Access Compliance Report

Public Rights-of-Way

Intersection ID: 16163	Main Street: HARRI_ANN_DR	Cross Street: LAWYERS_RD	Location: SE
ADA ID: F04BBE8E274B	Ramp Type: PerpDiag	Initial Pass/Fail: Fail	Overall Compliance: No
		Severity Score: 50

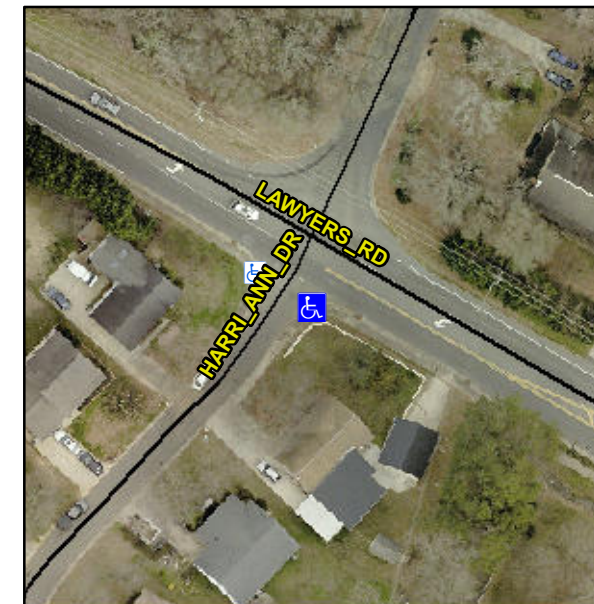
Not Found, R304.2.2, R304.5.3

Compliance	Description	Data	Compliance	Description	Data
N/A	Ramp Length (in)	56.0	No	Ramp Slope (%)	15.7
Yes	Ramp Width (in)	48.0	No	Ramp XSlope (%)	9.1
N/A	Flare Type LT	N/A	N/A	Flare Type RT	N/A
N/A	Flare Slope LT (%)	N/A	N/A	Flare Slope RT (%)	N/A
N/A	Flare Traversable LT?	N/A	N/A	Flare Traversable RT?	N/A
N/A	Landing Length (in)	N/A	N/A	DWS Provided?	N/A
N/A	Landing Width (in)	N/A	N/A	DWS Contrast?	N/A
N/A	Landing Slope (%)	N/A	N/A	DWS Length (in)	N/A
N/A	Landing X Slope (%)	N/A	N/A	DWS Full Width?	N/A
N/A	Landing Curb? (Y/N)	N/A	N/A	DWS Offset (in)	N/A
N/A	Shared Landing?	N/A			
N/A	Gutter Ponding?	N/A	N/A	Gutter Slope (%)	N/A
N/A	Gutter Lip Ht (in)	N/A	N/A	Gutter X Slope (%)	N/A
N/A	Painted X Walk1?	No	N/A	Painted X Walk2?	No
	X Walk 1 Direction	To NE		X Walk 2 Direction	To NW
N/A	X Walk 1 Width (in)	N/A	N/A	X Walk 2 Width (in)	N/A
	X Walk 1 Slope (%)	7.7		X Walk 2 Slope (%)	2.0
	X Walk 1 X Slope (%)	5.2		X Walk 2 X Slope (%)	5.6

Remove & Replace Curb Ramp With Two New Directional Ramps or Equivalent.
